CALGARY PLANNING COMMISSION

October 18, 2018, 1:00 PM
IN THE COUNCIL CHAMBER
Members

- 7.1.1 Policy Amendment and Land Use Amendment in Bridgeland-Riverside (Ward 9) at 1018 McDougall Road NE, LOC2018-0059, CPC2018-0968
- 7.1.2 Development Permit in Bridgeland-Riverside (Ward 9) at 1018 McDougall Road NE, DP2018-3108, CPC2018-1130

A2.03

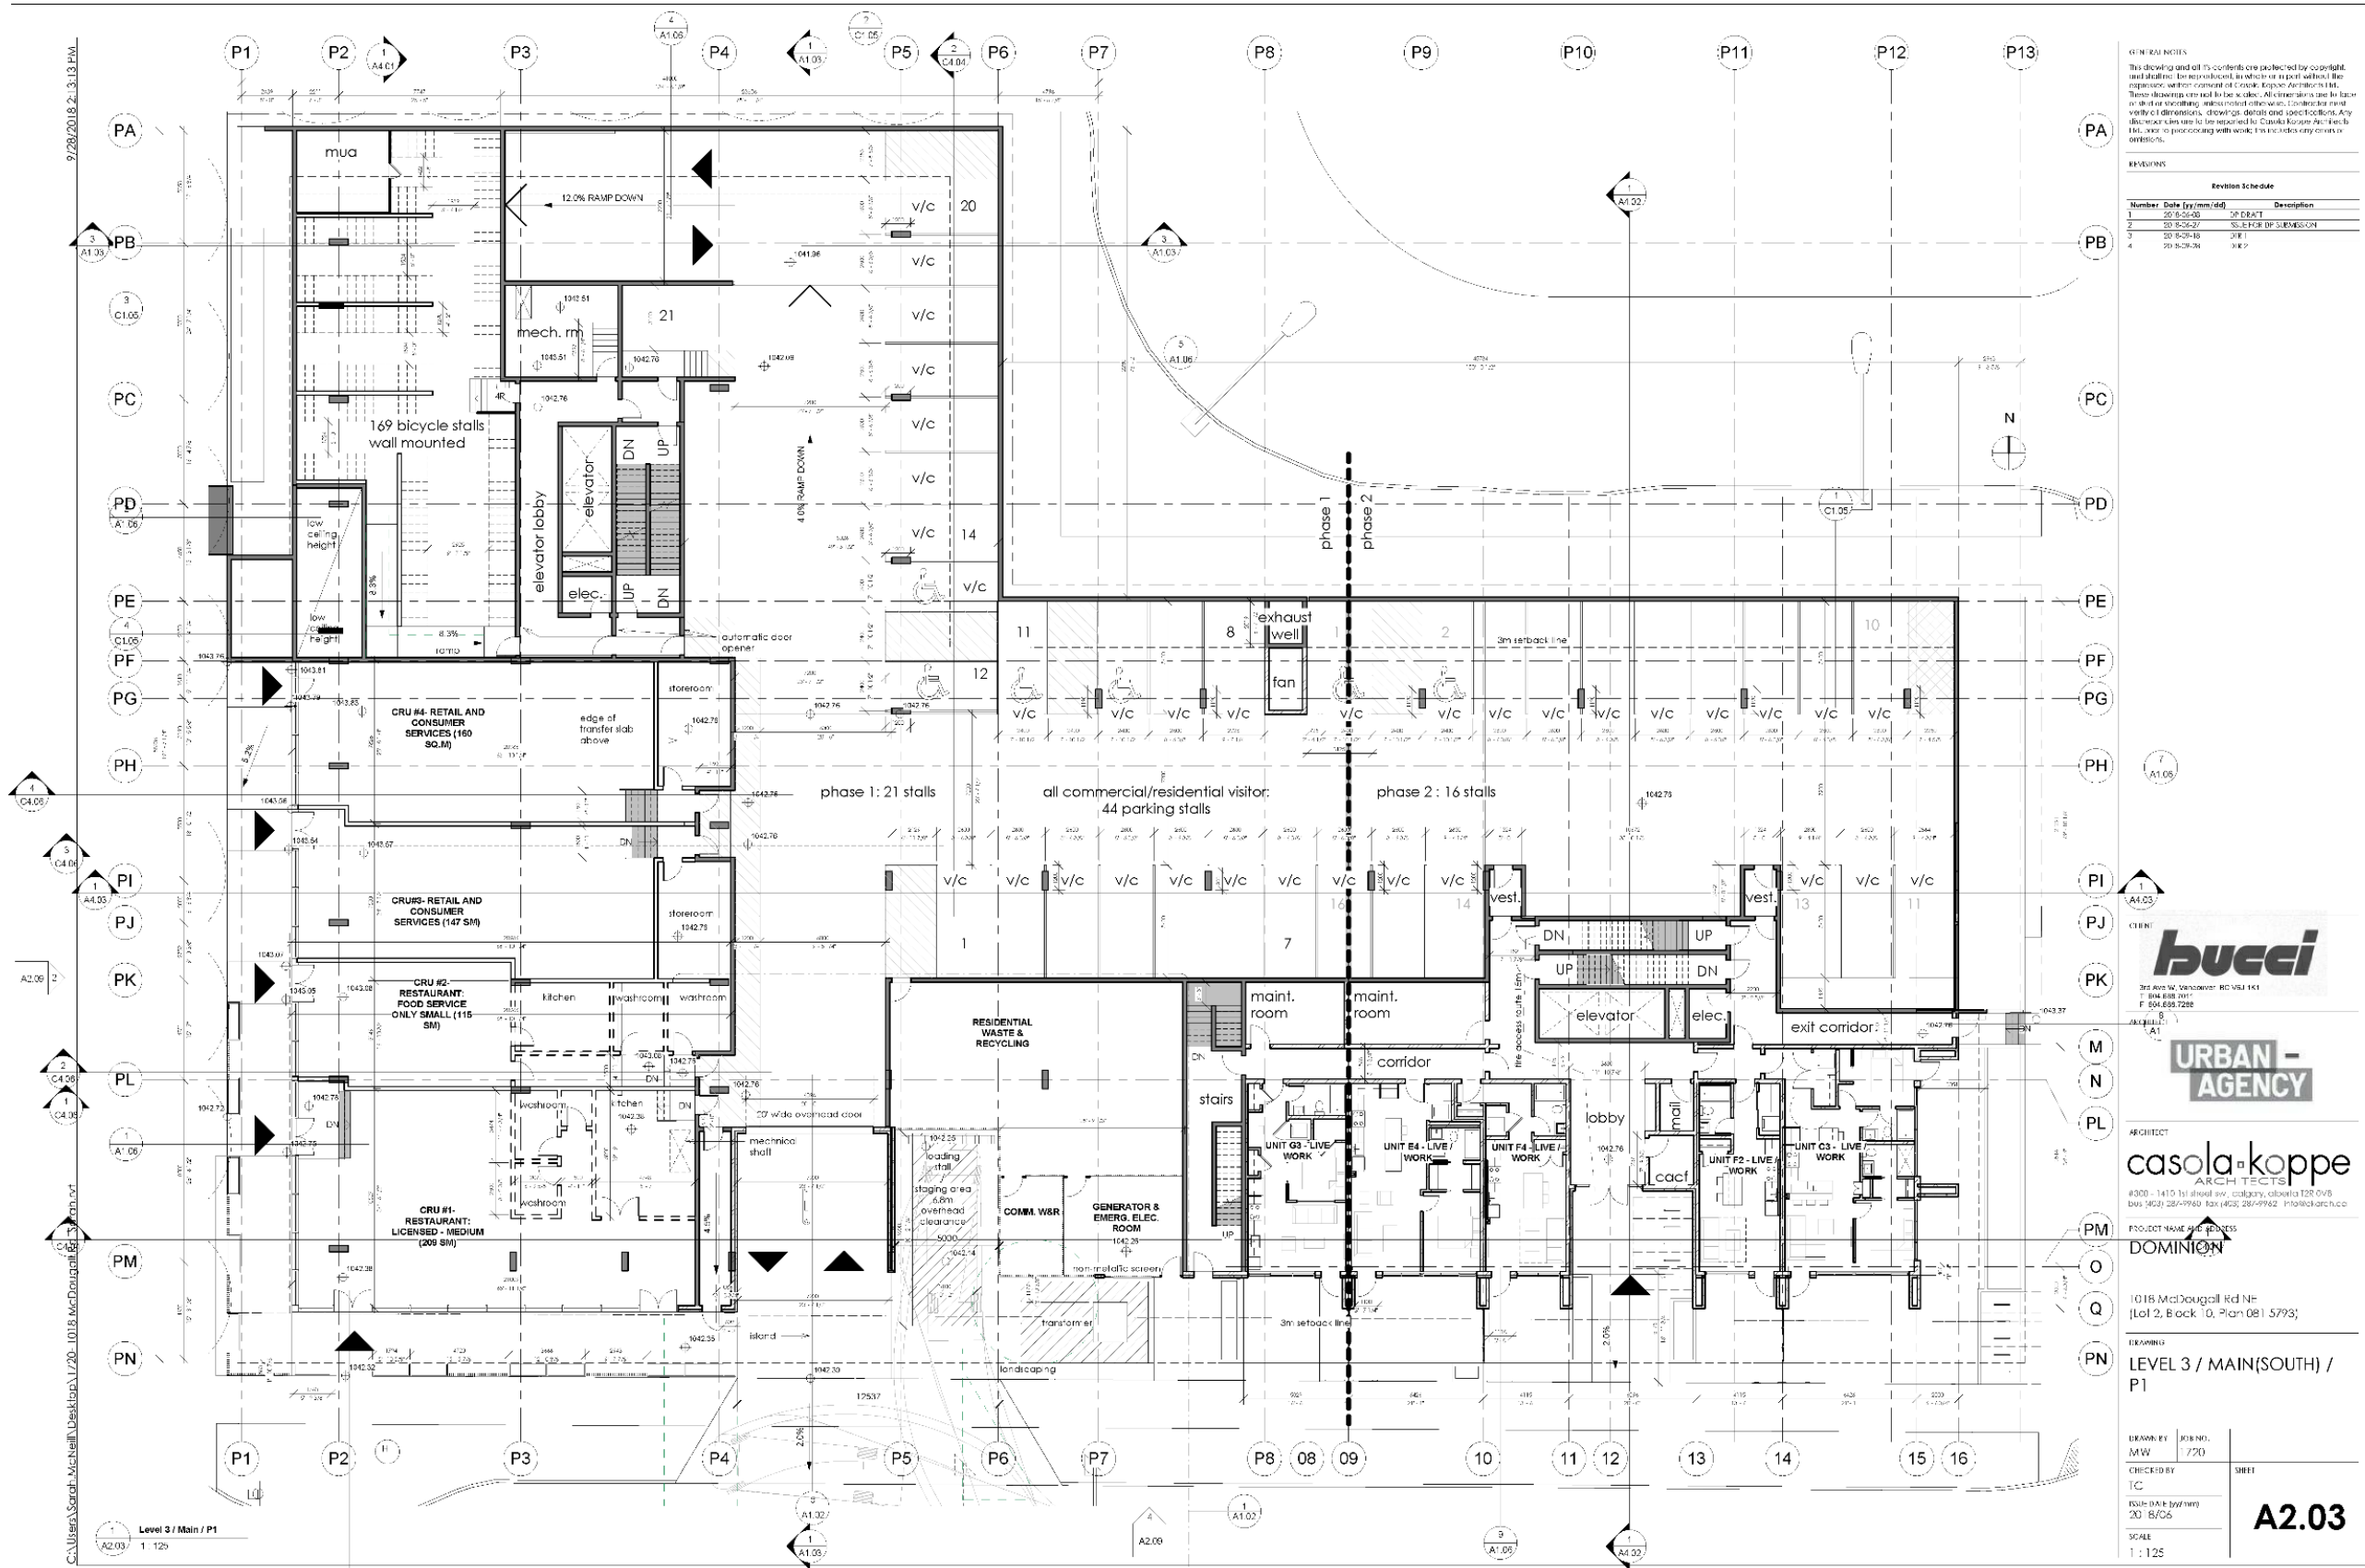
6. Amend drawing A2.02, P2 parkade plan to indicate stalls 1-7 to be Visitor/Commercial stalls.
7. Amend drawing A2.03, P3 parkade plan to indicate stall 21 to be Visitor/Commercial stalls.
8. Amend the total proposed parking stall count in the "Commercial Area Information" table on A2.09 to reflect the additional commercial/visitor stall count (44 stalls) and to break up the parking requirements for Dwelling Units vs Live Work Units.
9. Amend the "Zoning Compliance Table" on A1.01B to reflect the changes to commercial/visitor parking stalls and parking requirements for Dwelling Units vs Live Work Units.
